SUBJECT: WOLF CREEK GENERATING STATION - AMENDMENT NO. 99 TO FACILITY
OPERATING LICENSE NO. NPF-42 (TAC NO. M94882)

The amendment reduces the calculated thermal design flow of the reactor coolant system and increases the trip setpoint of the low pressurizer pressure.

SAFETY EVALUATION BY THE OFFICE OF NUCLEAR REACTOR REGULATION
RELATED TO AMENDMENT NO. 99 TO FACILITY OPERATING LICENSE NO. NPF-42

FIGURE 2.1-1
 REACTOR CORE SAFETY LIMIT - FOUR LOOPS IN OPERATION

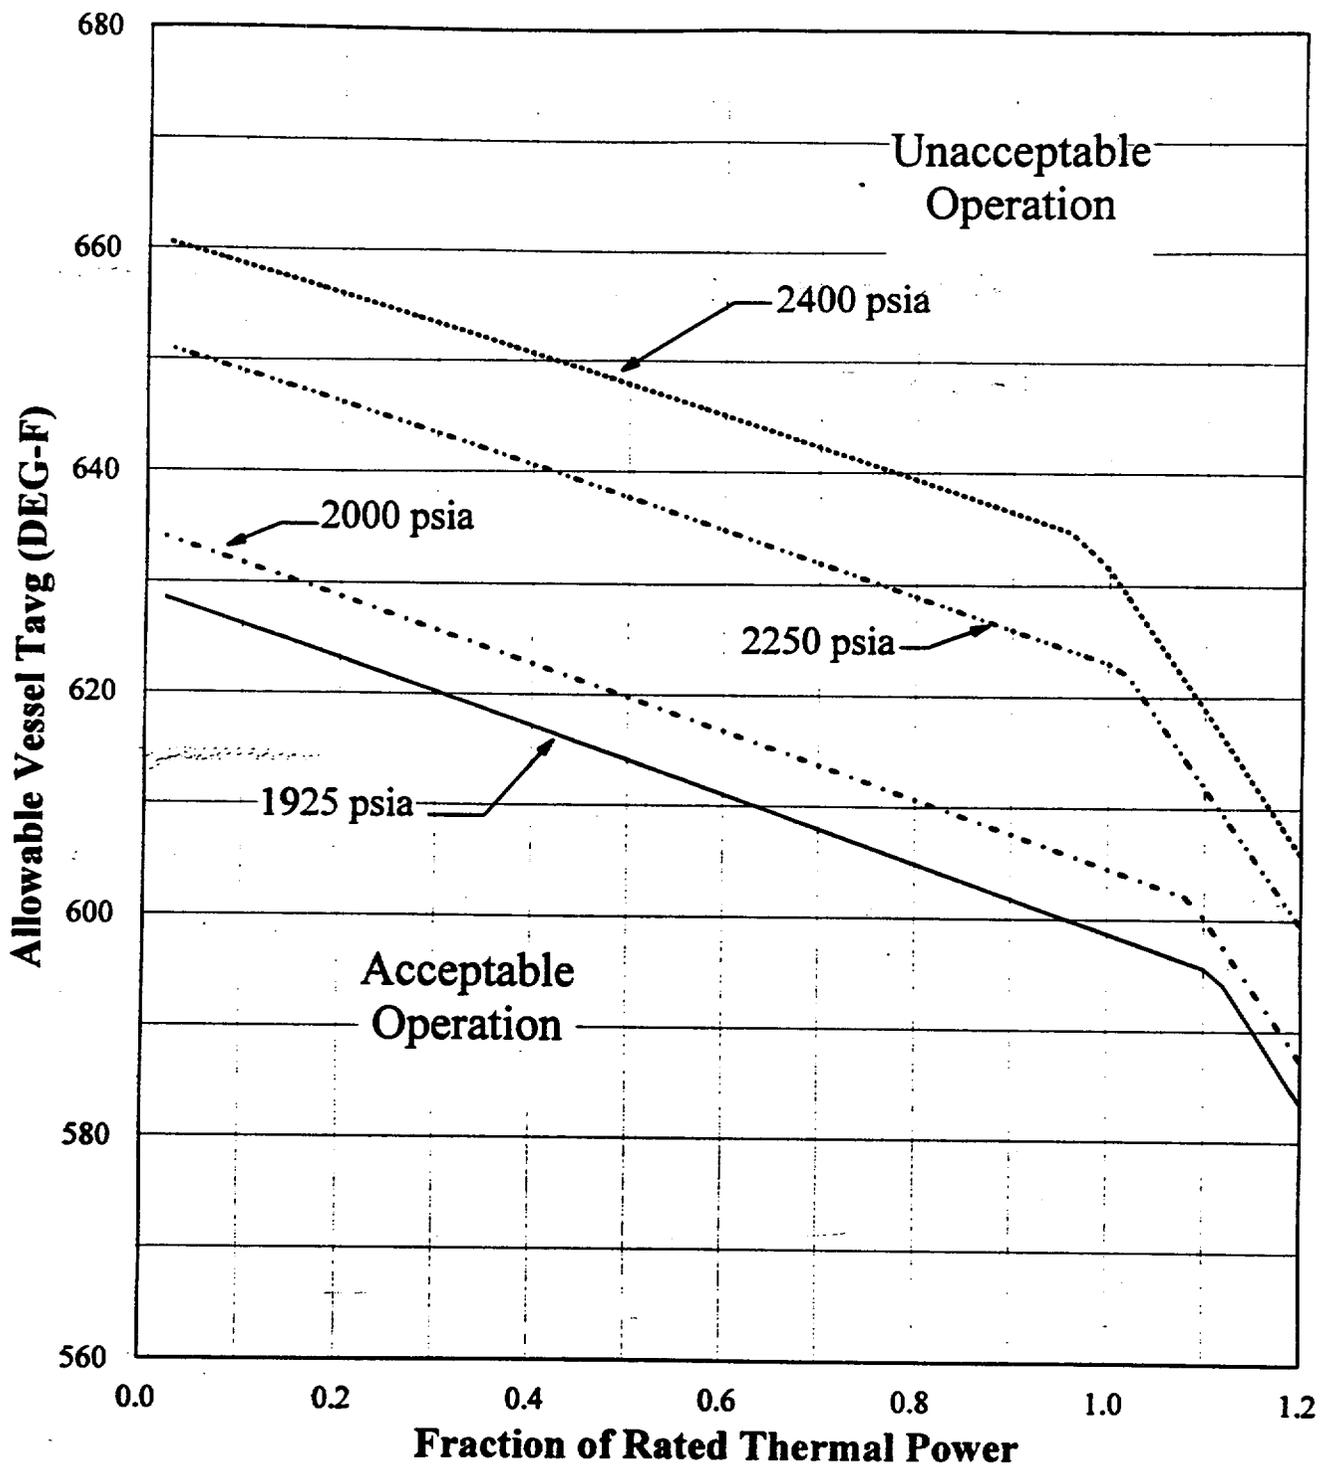
1. Modify Figure 2.1-1, Reactor Core Safety Limit - Four Loops in Operation to account for reduction in TS reactor coolant system (RCS) flow.
2. Change Table 2.2-1, Reactor Trip System Instrumentation Trip Setpoints as follows because of the reduction in TS RCS flow:

Figure 2.2-1 is being changed to account for the 3.5% decrease in reactor coolant system flow and the 25 psi increase in the pressurizer pressure trip setpoint to ensure continued protection from DNB. The staff finds that this change is consistent with the licensee's safety analysis and acceptable.
